**RESOLUTION SCHEDULING PUBLIC HEARING ON APPEAL BY
CASEY'S MARKETING COMPANY OF THE CONDITIONAL APPROVAL
OF A SITE PLAN FOR 6120 DOUGLAS AVENUE**

APPROVAL of a request from Casey's Marketing Company (developer) represented by Michael R. Richardson (officer) for review and approval of a Site Plan under design guidelines for convenience stores and gas stations on property located at 6120 Douglas Avenue, to allow development of a 3,920 square-foot convenience store with a 7,524 square-foot pump island canopy and 16 fueling stations subject to the following: 10-2010-7.22

Casey's Marketing Company - 6120 Douglas Avenue

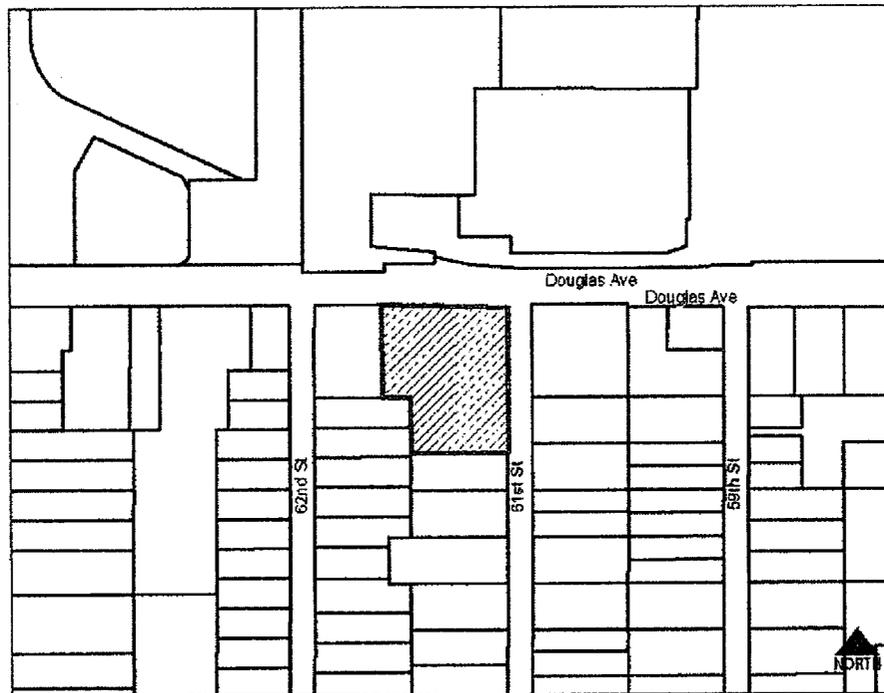
1. Compliance with all administrative review comments by the Permit and Development Administrator.
2. Provision of a shared-access drive connection with the commercial property to the west.

3. Re-routing the proposed pedestrian connection from the retail building entrance to the public sidewalk in 61st Street so that it is located along the south edge of the parking area east of the building.

4. Modification of the proposed trash enclosure and can recycling shed designs to be architecturally compatible with the primary commercial building. The trash enclosure shall have opaque metal gates.

5. Provision of a site wall to match the architecture of the building, a solid wood fence, or a dark solid vinyl or metal panel screening system for mechanical equipment south of the building in lieu of the proposed chain-link fence with slats.

6. Relocation of the proposed monument sign outside the vision clearance triangle for the intersection of 61st Street and Douglas Avenue. Any monument sign should also be comprised of materials that are compatible with the primary architecture of the building and subject to review and approval by the CD Director.

7. Modification of the overall canopy height to a maximum of 18 feet with a clearance height of at least 13-feet, 9-inches.
8. Provision of two additional over-story tree plantings within the south and southwest buffer yard planting area.

9. Demonstration that the Encore Top Access Focus flood light fixtures will not project below the pump island canopy with their source visible from the any adjoining property.

10. Provision of a compliant photometric prior to final approval.

11. Provision of elevations details for site lighting that is not mounted on the building with all pole heights at 20 feet or lower.

Staff believes that the building is appropriately sited on the property with the canopy separated from the neighborhood by the retail building.

Staff believes that there is opportunity for shared access with the adjoining office building site to west. The developer should seek cross access connections to this existing commercial site as a condition of approval for this convenience store site plan.

Staff believes the existing site and the proposed amendment generally conform to these provisions. There are no auto repair bays or drive-through windows. The proposed screening method is discussed further within the landscape guidelines section of the report. The refuse container and beverage container recycling storage should be more appropriately screened with an enclosure that matches the architecture of the primary structure. Also staff does not believe the chain-link fencing with slats is the most appropriate method for screening the condenser units on the south side of the building which is oriented toward the residential neighborhood. Either a site wall to match the architecture of the building, a solid wood fence, or a dark solid vinyl or metal panel screening system would all be more appropriate alternatives.

Staff believes that the existing site conforms to this provision to some extent. However, the sidewalk connection proposed from the store to the public sidewalk on 61st Street should be rerouted along the south edge of the parking lot so that pedestrians are not walking behind parking spaces.

The pump island canopy is proposed with a 16'-6" clearance from grade and a 20'-3" overall height. Staff believes the canopy should be adjusted to meet these requirements by lowering the clearance to 14'-3".

Staff believes that two additional over-story trees are required to conform with the minimum plantings under the design guidelines. The plan is proposed with dense evergreen planting pattern along the southern and southwestern property boundaries with residential uses.

However, the proposed chain-link screens for the trash enclosure and mechanical equipment to the rear of the building are not adequate. Any trash enclosure should be architecturally compatible with the primary building with durable opaque metal gates. Staff also does not believe the chain-link fencing with slats is the most appropriate method for screening the mechanical units on the south side of the building which is oriented toward the residential neighborhood. Either a site wall to match the architecture of the building, a solid wood fence, or a dark solid vinyl or metal panel screening system would all be more appropriate alternatives.

No elevation of the typical monument sign was provided. It must be relocated out of the street vision clearance. Staff believes that it shall be of materials that are compatible with the primary building in order to comply with this design guideline.

Staff believes that the submitted photometric plan indicates a few locations along the west commercial boundary where calculated illuminance will exceed 2.0 footcandles and along the southwest residential boundary where illuminance will exceed 0.5 footcandles. Staff recommends that the lighting plan be adjusted to comply with this provision.

The submitted plan indicates all cut-off type fixtures to be used. If the developer proposes use of cut-off focused flood lighting, then it must be recessed above the bottom level of the canopy.

Staff was not provided with the pole heights of the proposed freestanding lighting. Staff recommends that a plan in accordance with these provisions be submitted as a condition of any approval to ensure compliance with the guidelines.

The plan proposes a series of underground detention cells to provide stormwater management. It should also be noted that an existing 30-inch storm sewer that runs under the current vacant restaurant building will be rerouted within the site at considerable expense so that the pump island canopy will not be over the storm sewer or necessary easements.

1. Compliance with all administrative review comments by the Permit and Development Administrator.
2. A 24 foot wide access shall be provided to the property to the west at a mutually agreed upon location between the two property owners should the adjoining site to the west be redeveloped.

3. Re-routing the proposed pedestrian connection from the retail building entrance to the public sidewalk in 61st Street so that it is located along the south edge of the parking area east of the building.

4. Modification of the proposed trash enclosure and can recycling shed designs to be architecturally compatible with the primary commercial building. The trash enclosure shall have opaque metal gates.

5. Provision of a site wall to match the architecture of the building, a solid wood fence, or a dark solid vinyl or metal panel screening system for mechanical equipment south of the building in lieu of the proposed chain-link fence with slats.

6. Relocation of the proposed monument sign outside the vision clearance triangle for the intersection of 61st Street and Douglas Avenue. Any monument sign should also be comprised of materials that are compatible with the primary architecture of the building and subject to review and approval by the CD Director.

7. Modification of the overall canopy height to a maximum of 18 feet-9 inches with a clearance height of at least 13-feet, 9-inches.

8. Provision of two additional over-story tree plantings within the south and southwest buffer yard planting area.
9. Demonstration that the Encore Top Access Focus flood light fixtures will not project below the pump island canopy with their source visible from the any adjoining property.
10. Provision of a compliant photometric prior to final approval.
11. Provision of elevations details for site lighting that is not mounted on the building with all pole heights at 20 feet or lower.
